**Design Review Board Case #2017-0002**  
**Eisenhower East - Block 20**

| Application  | General Data             |                         |
|--|--------------------------|-------------------------|
| <b>Purpose of Application:</b> Third design concept review of the proposed development for Eisenhower East Block 20. The proposal includes 484,034 sf of residential and 100,960 sf of hotel.  |                          |                         |

Figure 3.1- May 1<sup>st</sup> Concept

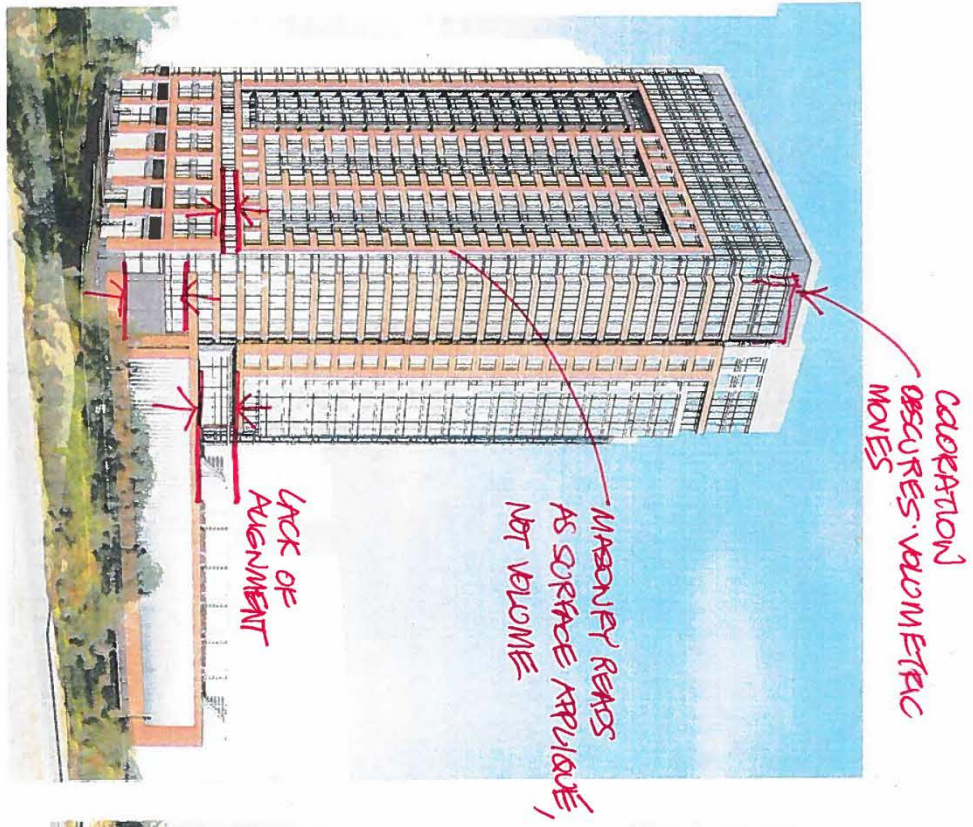
Second, while the sense of depth and layering has been strengthened again, especially when viewed from the south, the equal height of the light-colored penthouse/screen level seems to negate these efforts to some degree. Staff asks applicant to study creating a strong contrast in height between the two expressed penthouse masses, as was the case in the May 1<sup>st</sup> iteration, to create the effect of "bundled towers" contained by the outer brick and glass wrappers.

Third, still looking at the southwest corner of the revised design, and comparing it with the May 1<sup>st</sup> submission, the two narrow, single-story brick spandrels linking the west and south brick fields seem to preclude the strong reading of a massive brick skin embedded in the mass of the tower which was so evident and successful in the original. Staff suggests elimination of these bands, combined with additional subtractive massing above and below the brick fields, to allow the massive west-facing brick wall to be expressed three-dimensionally. Combined with varied penthouse heights, this could also help make the building's skyline more active and dynamic. Refer to Figures 3.1-3.3 for sketches which diagram this and the preceding Staff suggestions.
